Commissioner for Patents
Page 3

REMARKS

Figure 3

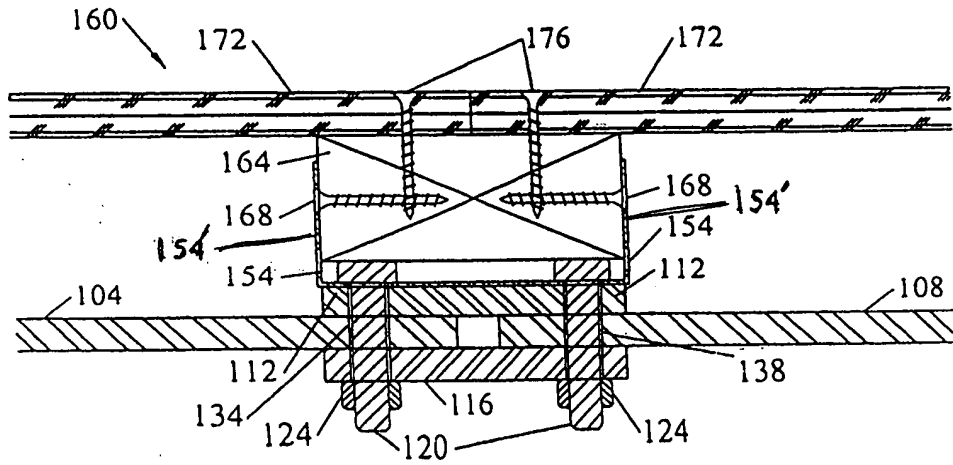
Please amend FIG. 3 as indicated

specification and the drawing to clearly identify the at least one arm connected to the facing strip and extending away from the first piece of steel plate and the second piece of steel plate which is shown in FIG.3. The amendment to paragraph 41 and to FIG. 3 is clearly supported by FIG. 3 and claim 22 as originally filed. Thus, no new matter has been entered.

The arm 154' in FIG. 3 meets the limitation of cited language of Claim 21, as the arm , which is part of the mounting bracket 154 is attached to the facing strip 112 and extends away from the metal plates 104 and 108. This structure is also consistent with claim 22.
